Re: **LETTER OF TRANSMITTAL  
ROOMS TO GO STORE EXPANSION AND REMODEL  
18722 South Dixie Highway  
Cutler Bay, FL 33157  
POST BID ADDENDUM #5**

## **POST BID ADDENDUM NO. FIVE**

Incorporate the following revised CASCO drawings dated 01/29/2024, with revisions including, but not necessarily limited to, those listed below:

**POWER PLAN**  
**E2.2**

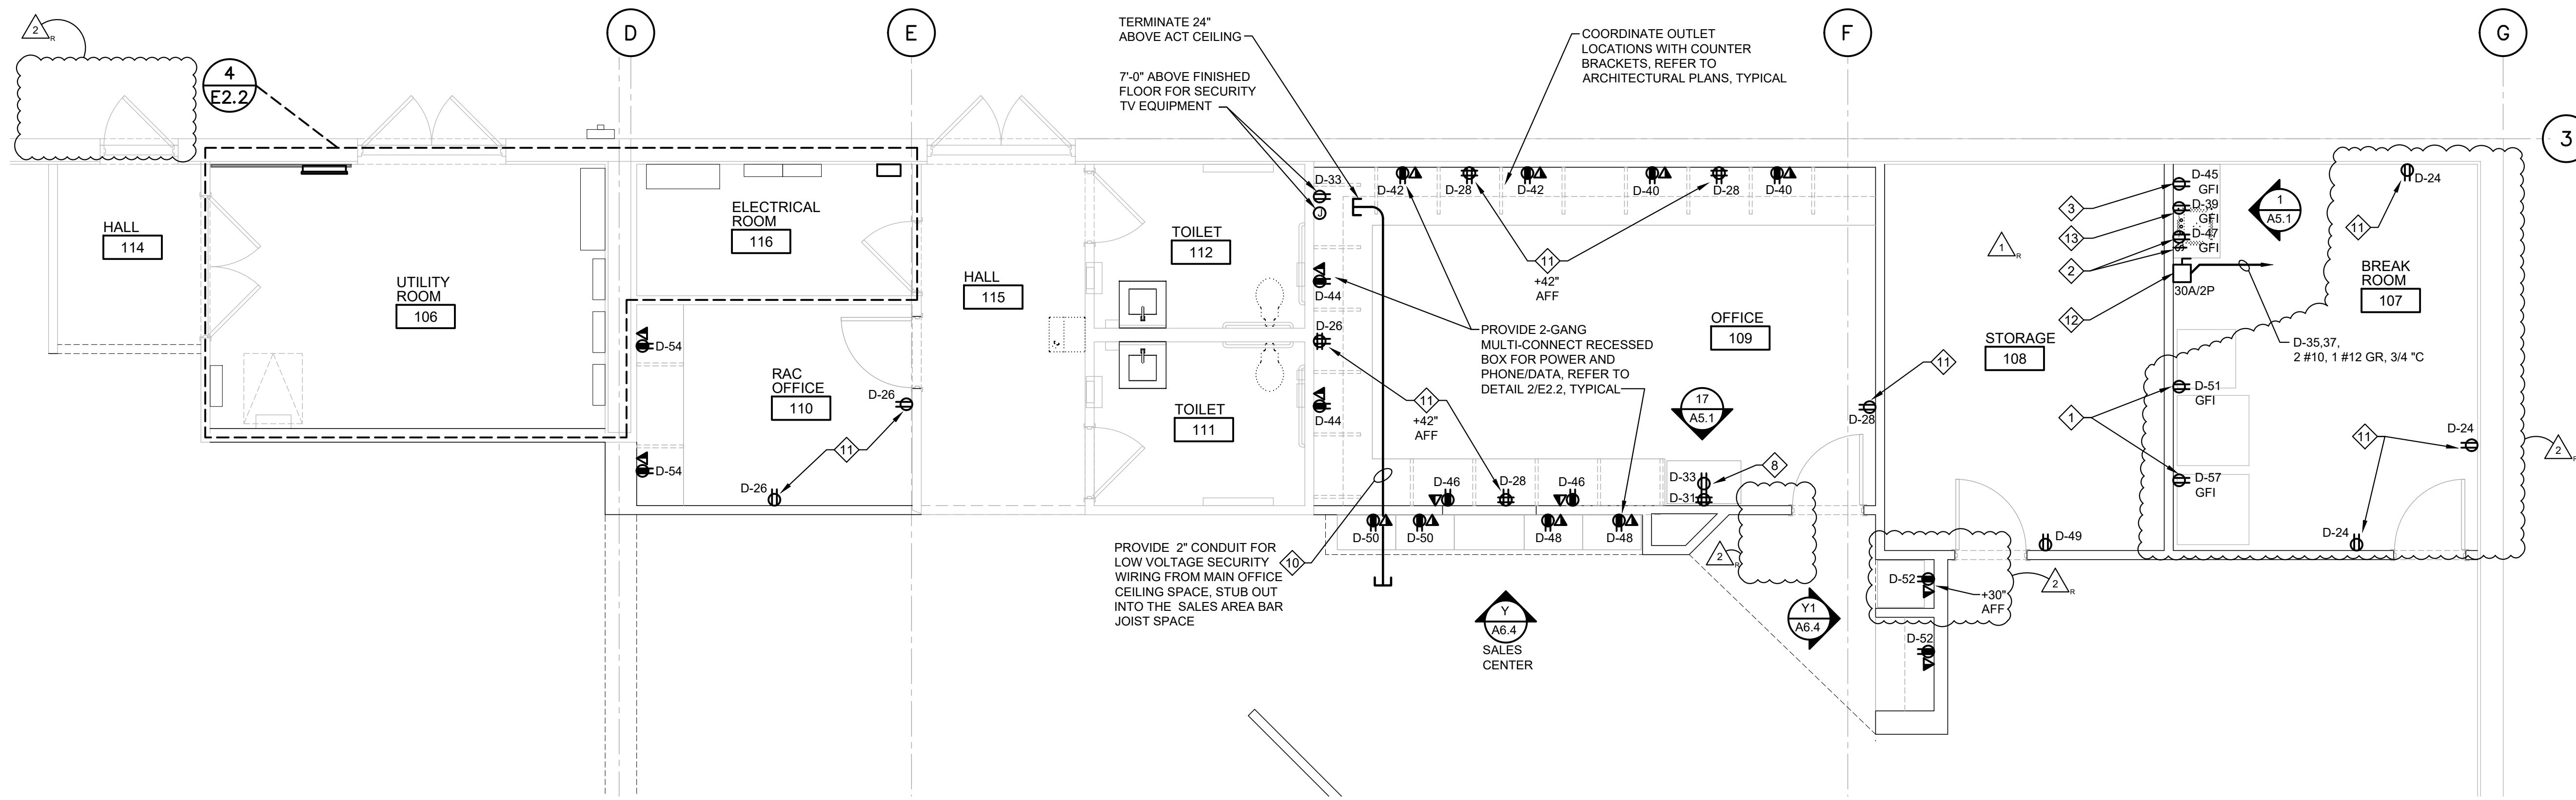
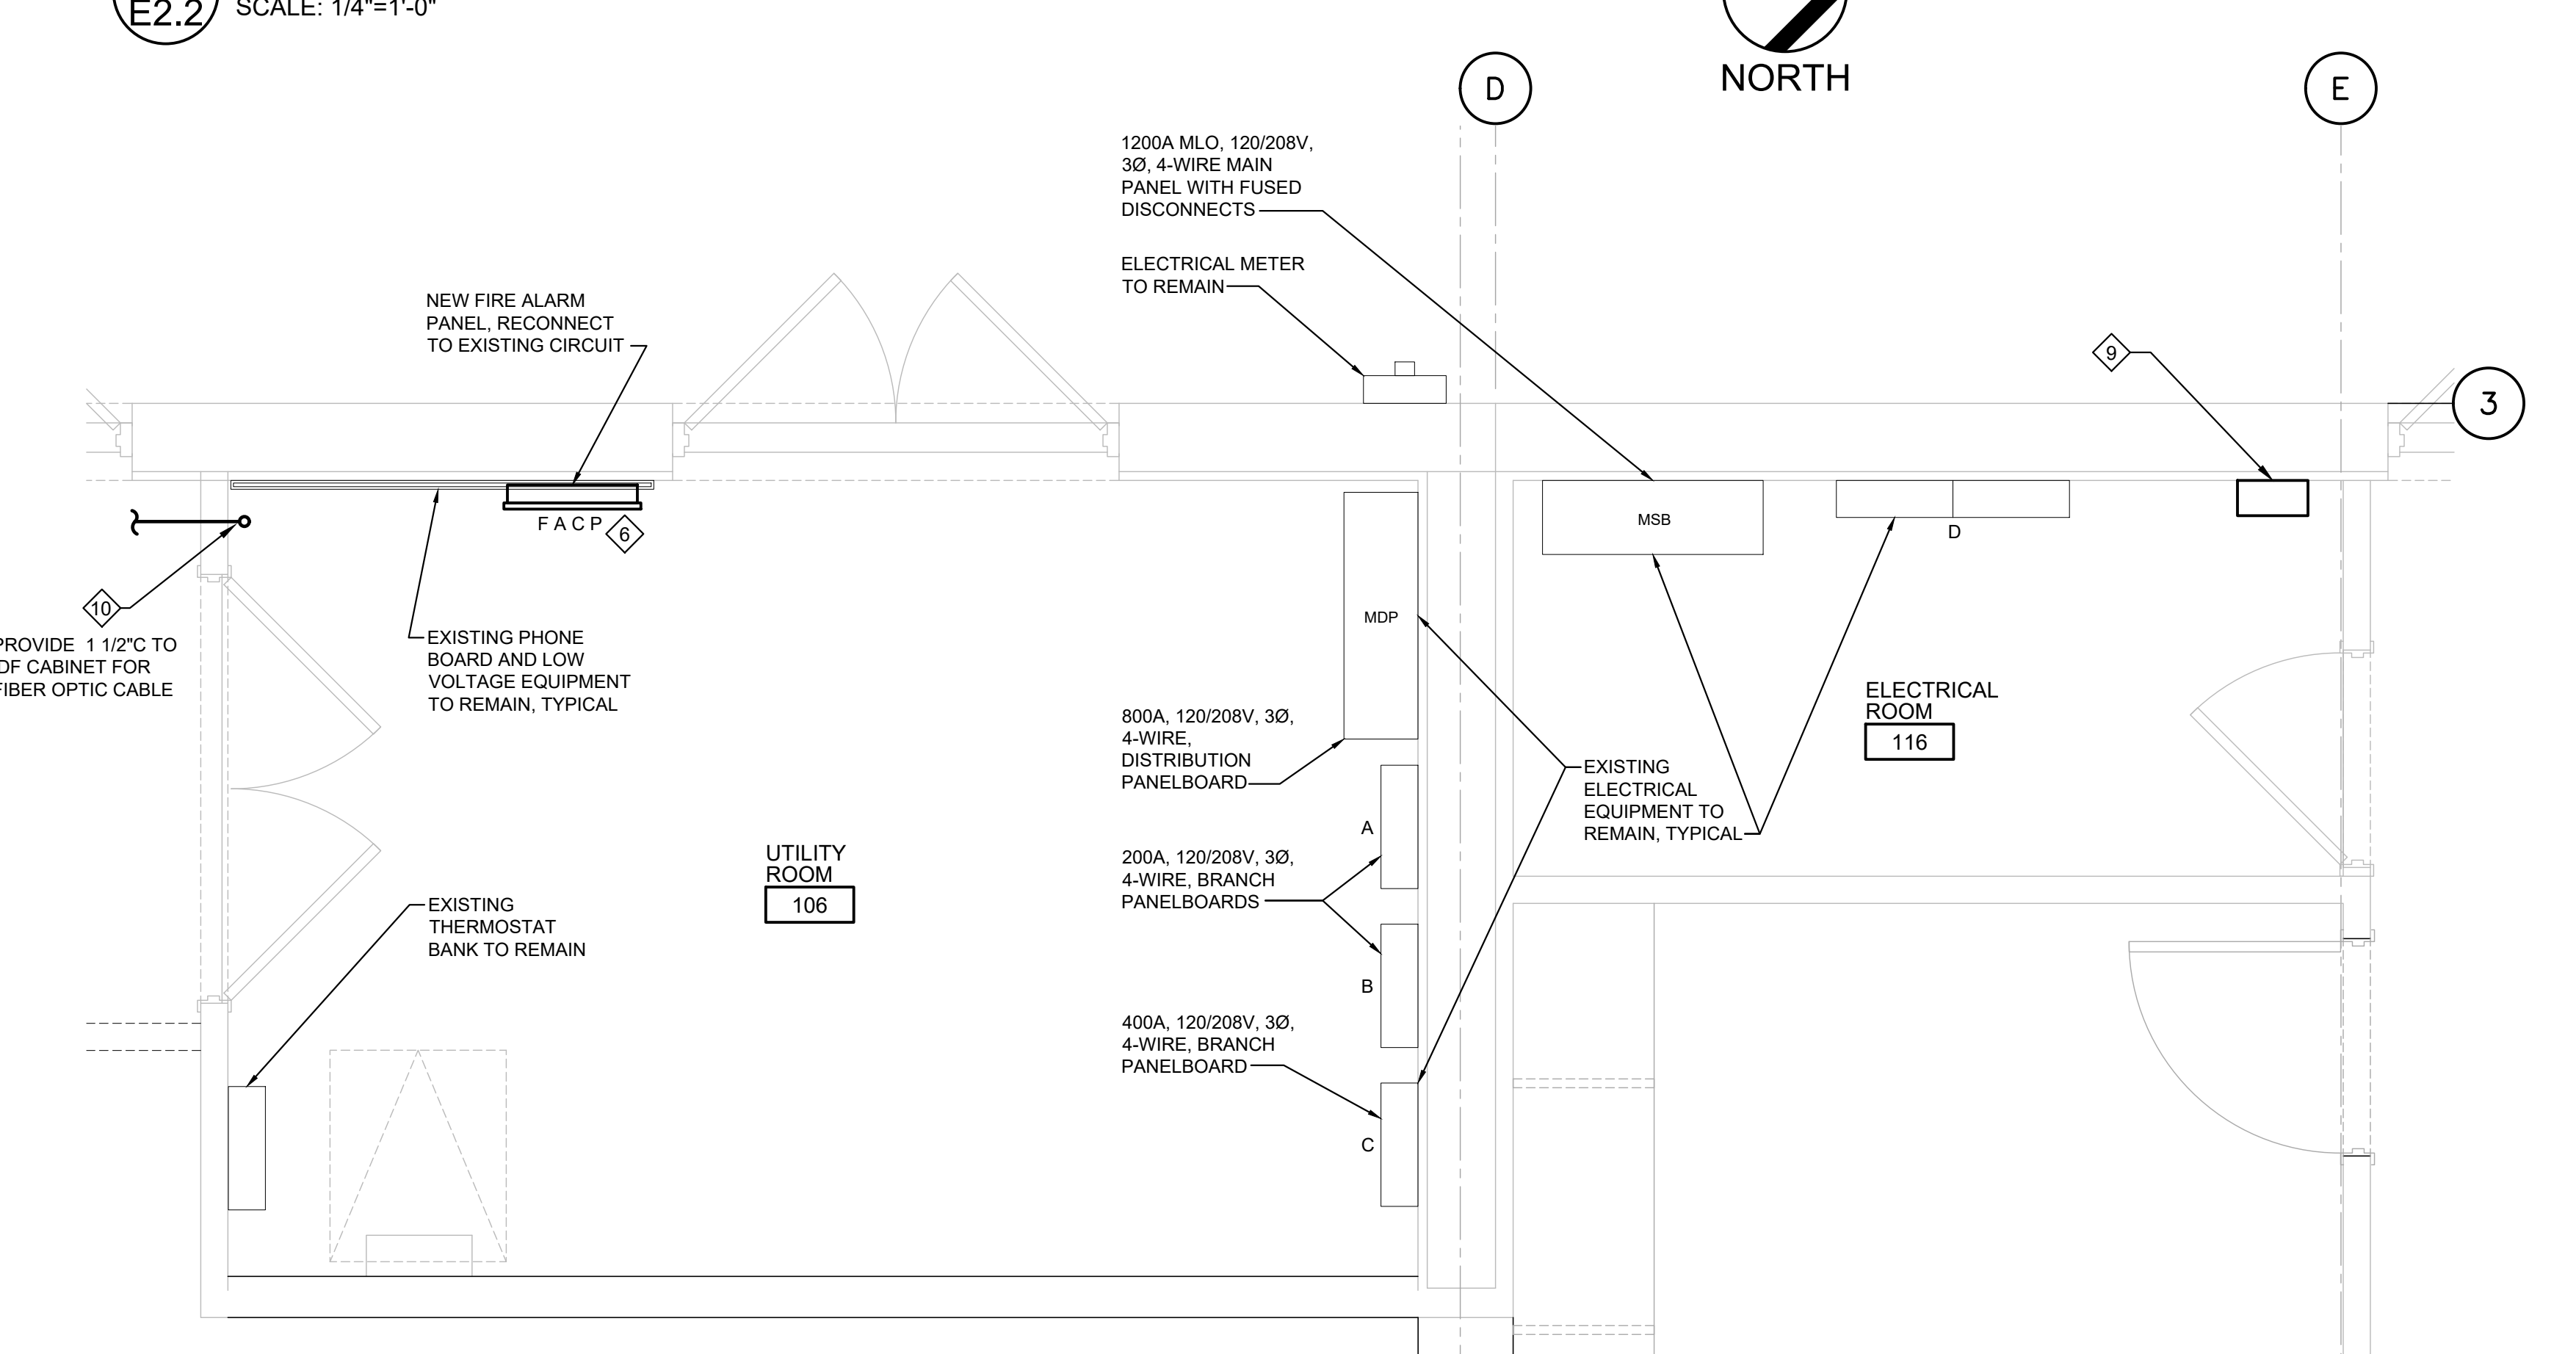
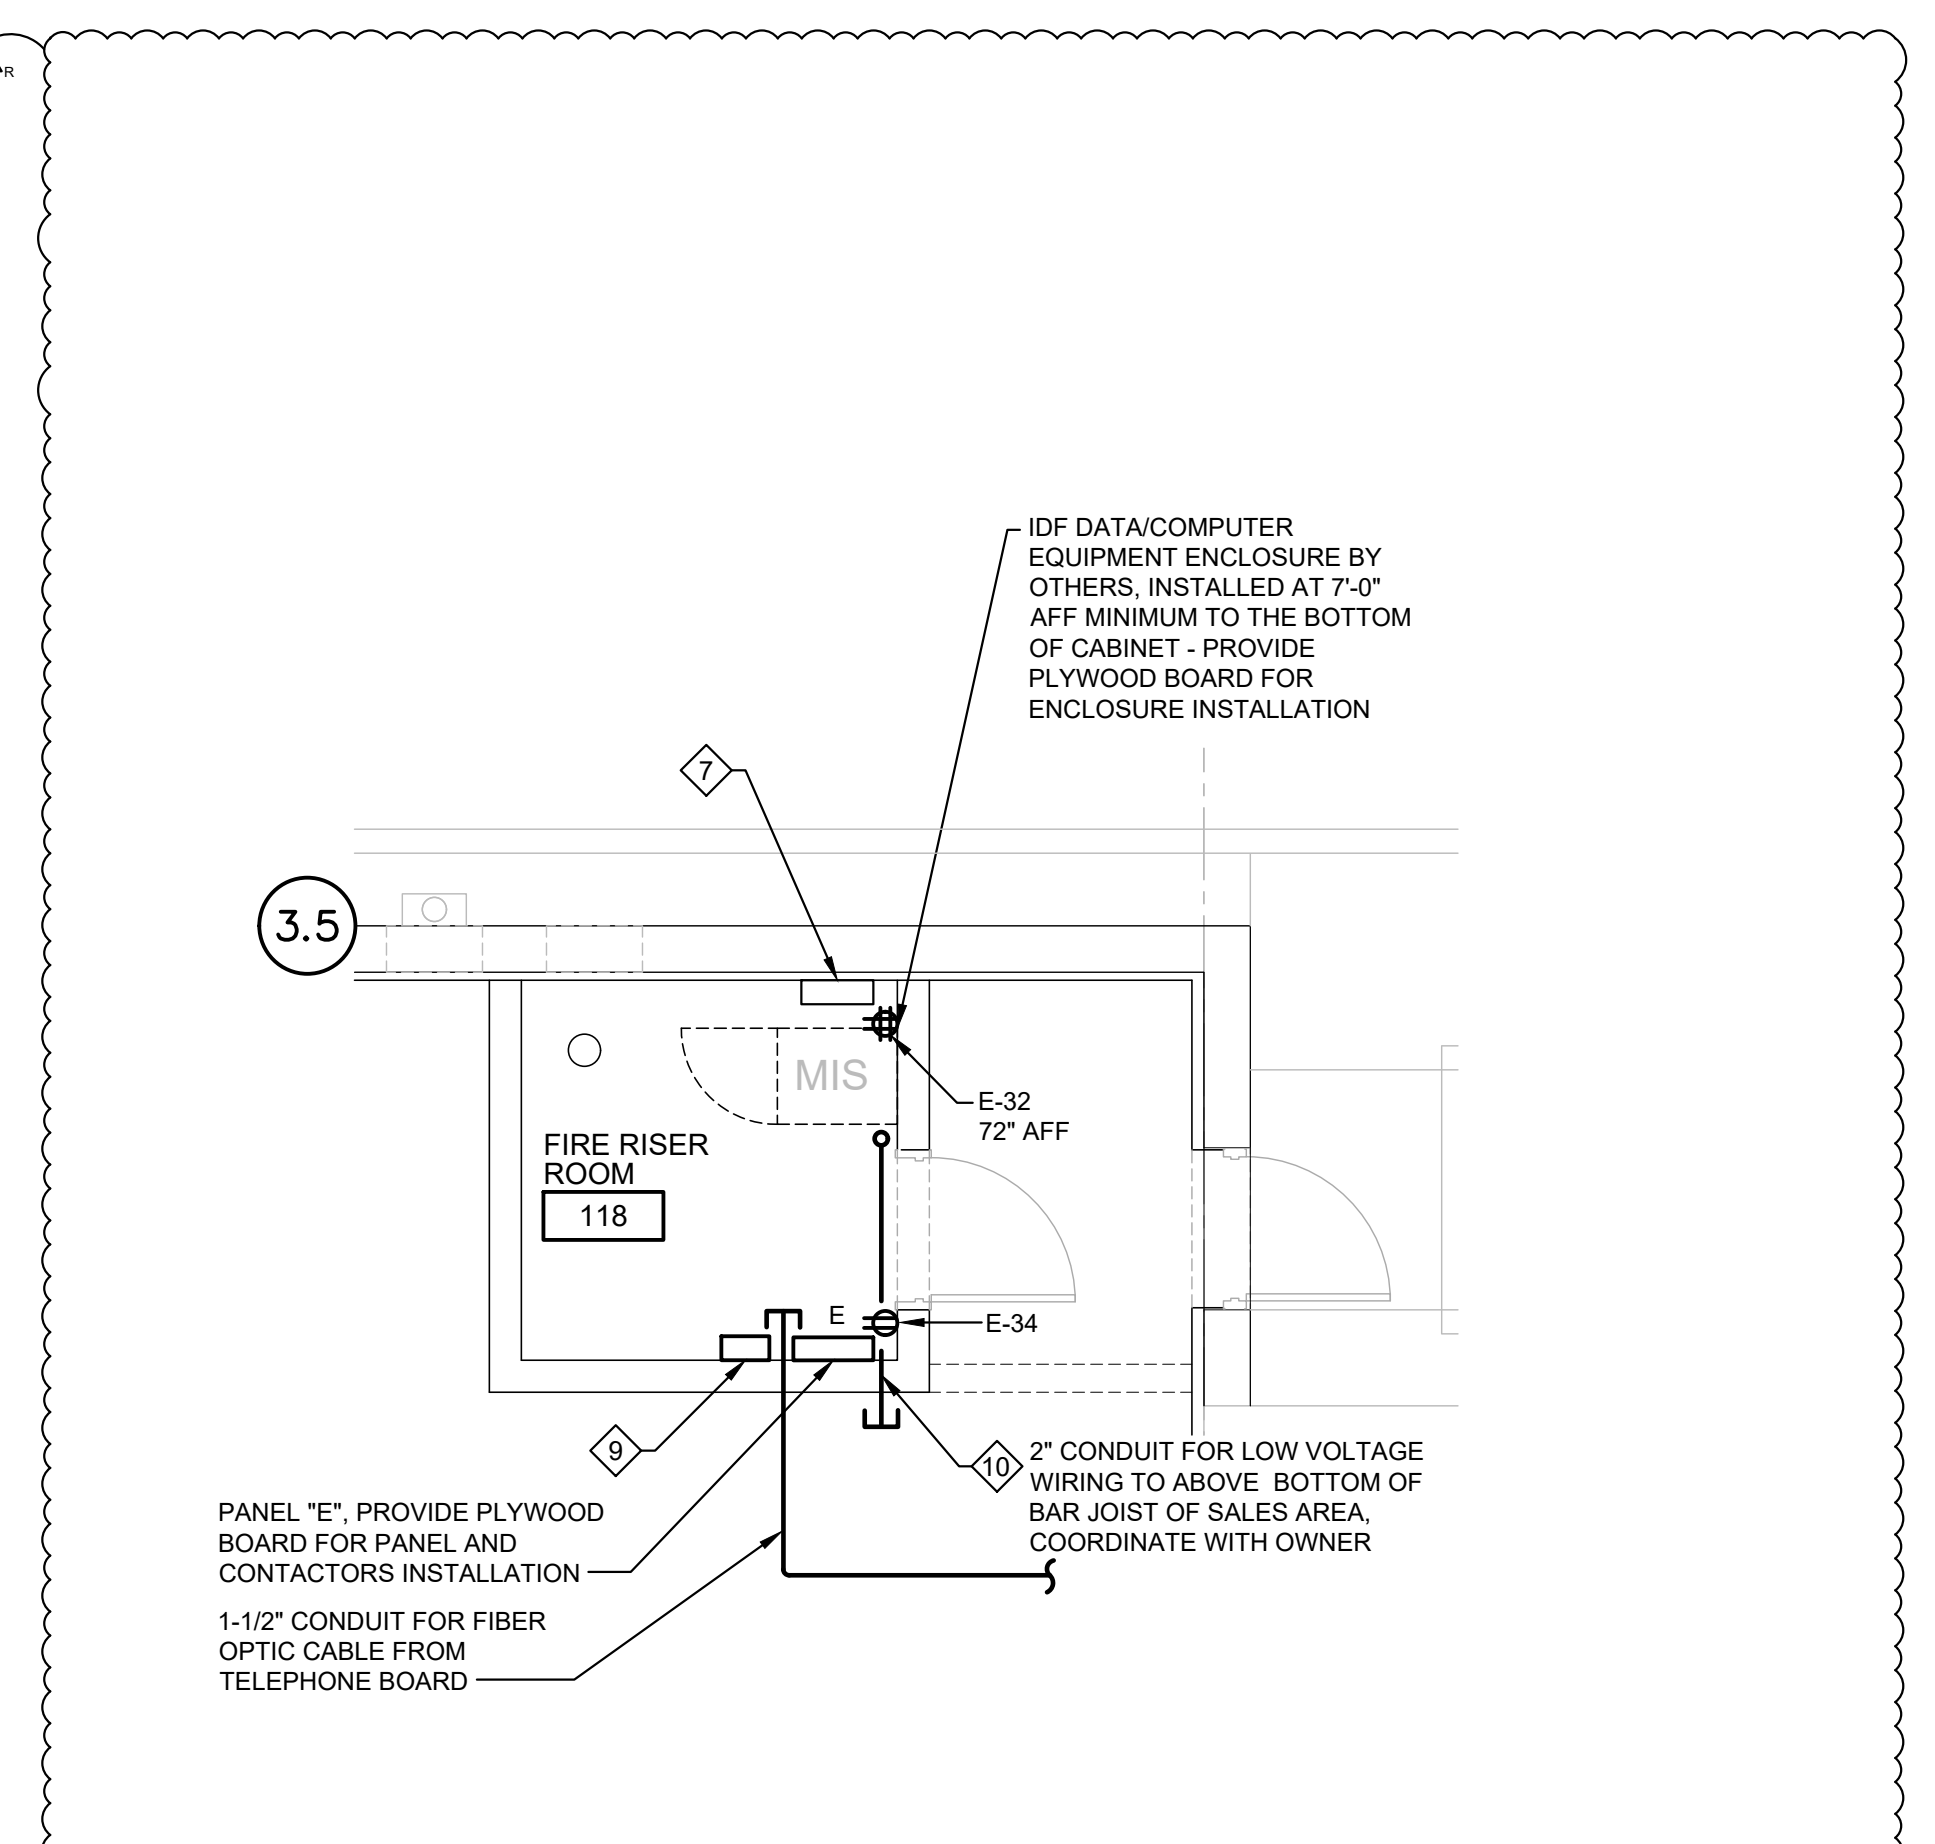
37. Sheet E2.2 – Revision No. 2: Removed receptacle for vending machine in Breakroom, and circuit for receptacle. Shifted two remaining vending receptacles. Replaced two quad receptacles with duplex receptacle in Breakroom. Removed circuit from remaining receptacle and changed to remaining controlled circuit. Removed push button and buzzer and removed associated keynotes. Added general note to clarify that conduit is not required for low voltage wiring. Remove power and data outlet for printer at interior elevation Y1. Removed IDF closet detail and replaced with Riser Room detail. Relocated panel E and other equipment and devices from IDF room to Fire Riser room.
